# Access Compliance Report

## Public Rights-of-Way (Curb Ramps)

Intersection ID: 12475	Main Street: AIRPORT_CENTER_PY	Cross Street: GOLF_ACRES_DR	Location: NE
ADA ID: A9426D0A6CF4	Ramp Type: PerpDiag	Initial Pass/Fail: Fail	Overall Compliance: No
		Severity Score: 55

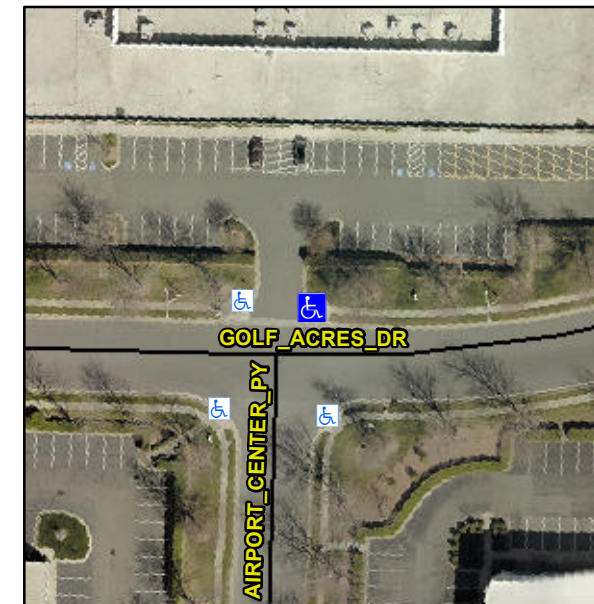
**Not Found, R304.5.1, R304.2.2, R304.5.3**

Compliance	Description	Data	Compliance	Description	Data
N/A	Ramp Length (in)	95.0	No	Ramp Slope (%)	9.3
No	Ramp Width (in)	32.0	No	Ramp XSlope (%)	10.0
N/A	Flare Type LT	N/A	N/A	Flare Type RT	N/A
N/A	Flare Slope LT (%)	N/A	N/A	Flare Slope RT (%)	N/A
N/A	Flare Traversable LT?	N/A	N/A	Flare Traversable RT?	N/A
N/A	Landing Length (in)	N/A	N/A	DWS Provided?	N/A
N/A	Landing Width (in)	N/A	N/A	DWS Contrast?	N/A
N/A	Landing Slope (%)	N/A	N/A	DWS Length (in)	N/A
N/A	Landing X Slope (%)	N/A	N/A	DWS Full Width?	N/A
N/A	Landing Curb? (Y/N)	N/A	N/A	DWS Offset (in)	N/A
N/A	Shared Landing?	N/A			
N/A	Gutter Ponding?	N/A	N/A	Gutter Slope (%)	N/A
N/A	Gutter Lip Ht (in)	N/A	N/A	Gutter X Slope (%)	N/A
N/A	Painted X Walk1?	No	N/A	Painted X Walk2?	No
	X Walk 1 Direction	To W		X Walk 2 Direction	To S
N/A	X Walk 1 Width (in)	N/A	N/A	X Walk 2 Width (in)	N/A
	X Walk 1 Slope (%)	0.5		X Walk 2 Slope (%)	3.3
	X Walk 1 X Slope (%)	13.2		X Walk 2 X Slope (%)	0.4

**Remove & Replace Curb Ramp With Two New Directional Ramps or Equivalent.**
